Access Compliance Report

Public Rights-of-Way

(Curb Ramps)

Intersection ID: 14765	Main Street: BONNYBROOK_LN	Cross Street: FARM_POND_LN	Location: SW
ADA ID: 8093E6E32311	Ramp Type: Directional1	Initial Pass/Fail: Fail	Overall Compliance: No
Severity Score: 22.5			
Codes/Mitigation Info/Possible Solution		Field Measurements/Component Compliance

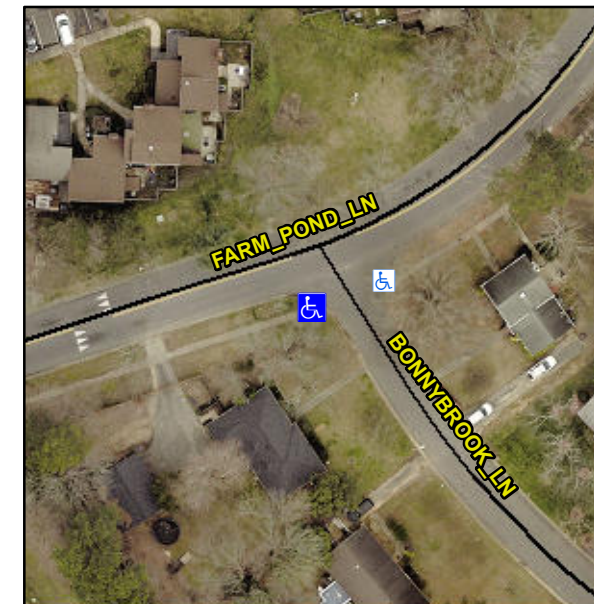
R304.5.1, R304.2.2, R304.5.3

Compliance	Description	Data	Compliance	Description	Data
N/A	Ramp Length (in)	69.0	N/A	Grade Break?	N/A
No	Ramp Width (in)	45.5	N/A	Grade Break Slope (%)	0.0
No	Ramp Slope (%)	8.4	N/A	Grade Break XSlope (%)	0.0
No	Ramp XSlope (%)	4.6			
N/A	Flare Type LT	N/A	N/A	Flare Type RT	N/A
N/A	Flare Slope LT (%)	N/A	N/A	Flare Slope RT (%)	0.0
N/A	Flare Traversable LT?	N/A	N/A	Flare Traversable RT?	N/A
N/A	Landing Length (in)	0.0	N/A	DWS Provided?	N/A
N/A	Landing Width (in)	0.0	N/A	DWS Contrast?	N/A
N/A	Landing Slope (%)	0.0	N/A	DWS Length (in)	N/A
N/A	Landing X Slope (%)	0.0	N/A	DWS Full Width?	N/A
N/A	Landing Curb? (Y/N)	N/A	N/A	DWS Offset LT (in)	N/A
N/A	Shared Landing?	N/A	N/A	DWS Offset RT (in)	N/A
N/A	Gutter Ponding?	0.0	N/A	Gutter Slope (%)	N/A
N/A	Gutter Lip Ht (in)	2.0	N/A	Gutter X Slope (%)	N/A
N/A	Painted X Walk1?	No		Road Slope (%)	4.3
	X Walk 1 Direction	To E		Road X Slope (%)	0.1
	X Walk 1 Width (in)	N/A		Clear Space?	N/A

Remove & Replace Entire Ramp.
